Notification of a Proposal to issue an Airworthiness Directive

PAD No.: 25-112

ATR 42 and ATR 72 aeroplanes

ATA 53 – Fuselage – Passenger Seat Tracks – Inspection / Replacement

Appendix 2- Identification of 'UACE' seat tracks manufactured in or after 2024

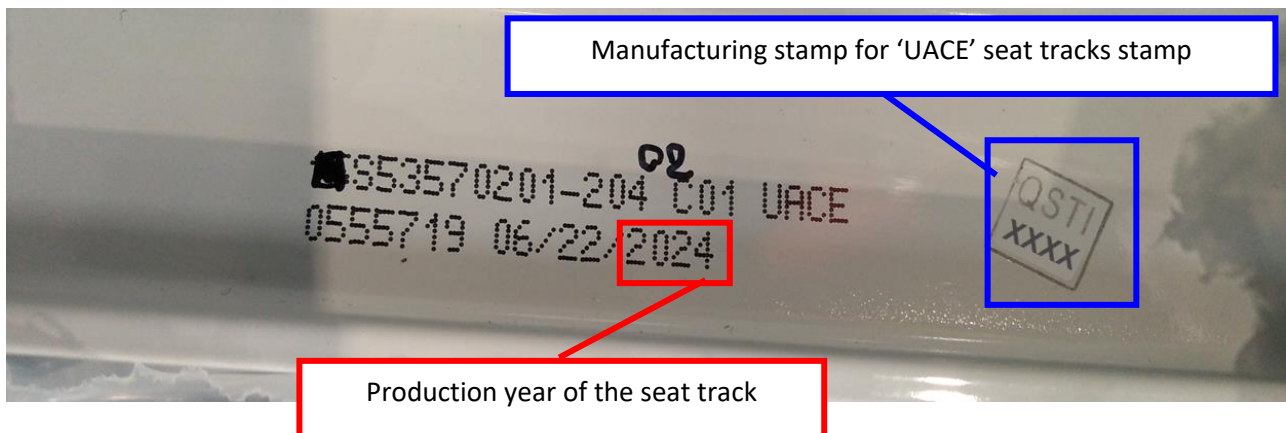
The identification of the seat track is located on the lower face of the seat track.

The manufacturing stamp of the seat track on the illustration corresponds to 'UACE' manufacturer, where 'XXXX' represents any numerical sequence.

The production year of the seat track on the illustration is 2024.

All the seat tracks having this manufacturing stamp and a production year equal or above 2024, do not have to be considered as affected parts.

All the seat tracks with the manufacturing stamp and/or production year not visible/legible, have to be considered as potential affected parts.
